January 12, 2018

**RE: Lot 5 Block 8 Unit 22 SAD 228  
Volcano Cliffs Subdivision  
6412 Canavio NW  
Request for Permanent C.O. - Accepted  
Engineers Stamp Date 5/24/17 (D10D003E5)  
Certification Dated: 1/10/18**

**GRADING AND DRAINAGE PLAN**

**LOT 5, BLOCK 8, UNIT 22, VCS**

GRADING & DRAINAGE PLAN  
6412 Canavio Place NW  
LOT 5, BLOCK 8, UNIT 22 VCS

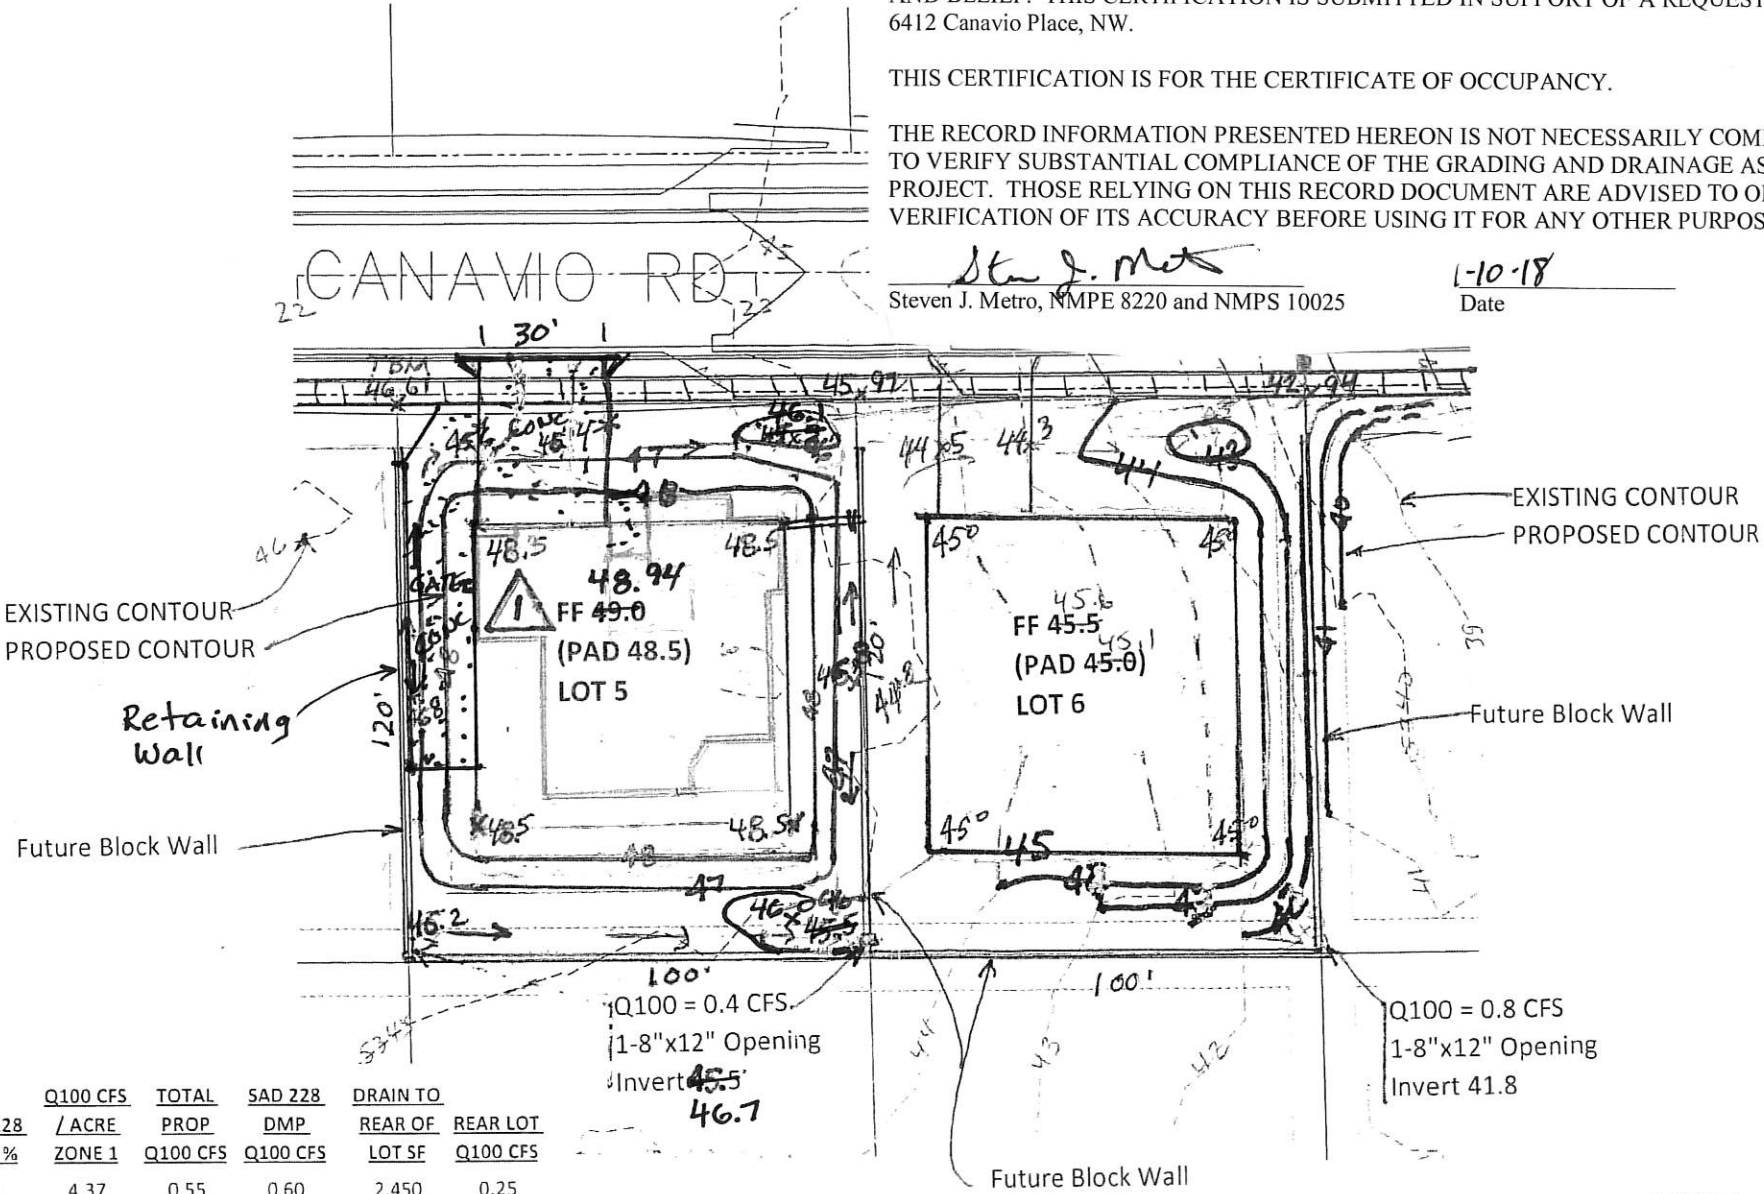
Based on the Certification received 1/12/2018, the above mentioned residence is acceptable for release of Certificate of Occupancy by Hydrology.
